Subject: Bell Cottages-2017-CU-003
PACE Project No. 18235.40.02

Thank you for the opportunity to complete a review of the proposed cluster housing development Bell Cottages.

SECTION A

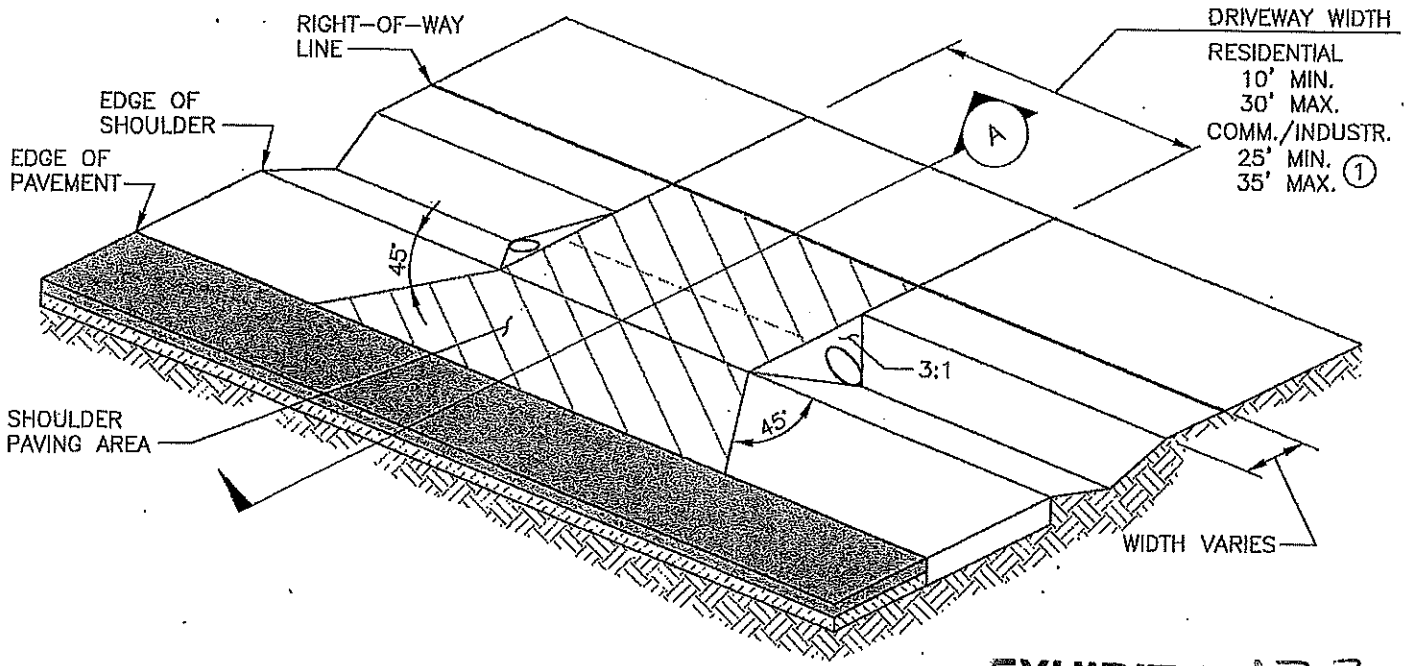
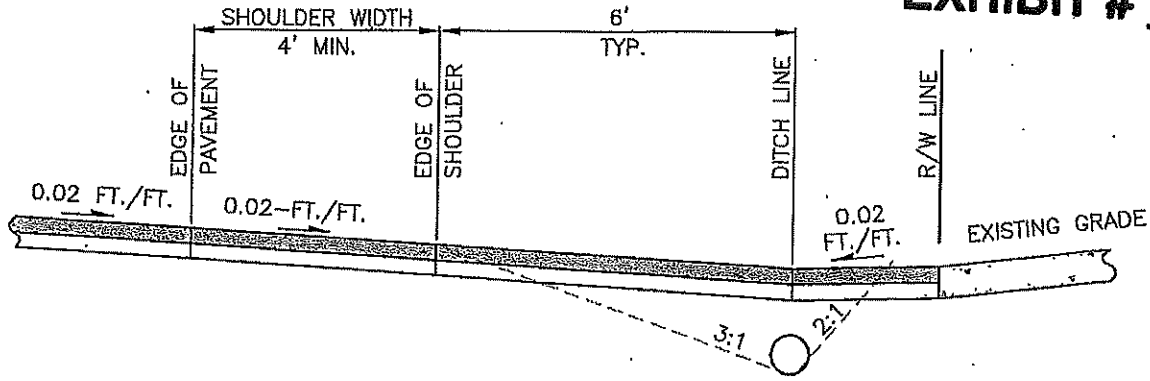
1. While there is currently no guidance for the type/design of the driveway/driveway entrance it is our professional opinion that the development most closely resembles a commercial/multifamily development such as a condo building or a townhome development. As such we would suggest a driveway entrance with a minimum width of 25'. If there were to be no curb and gutter and sidewalk proposed on the project's frontage the driveway approach should meet King County Roadway Standard Figure 3-003 (although there is no ditch in this project). The additional 7' of width vs a joint access tract would be welcomed especially if there are no sidewalk connections from the ROW onto the site.

The reference to an additional 7' was in reference to the 18' minimum width vs what they were proposing. My apologies for the confusion.

I think that if they agree to put in some sidewalk and curb and gutter that we definitely could allow the 20' width. I was just concerned with pedestrians walking out of the development within the driveway with two-way traffic present. It might not happen frequently but if it does that is not much space and the walkway wouldn't be separated from traffic.
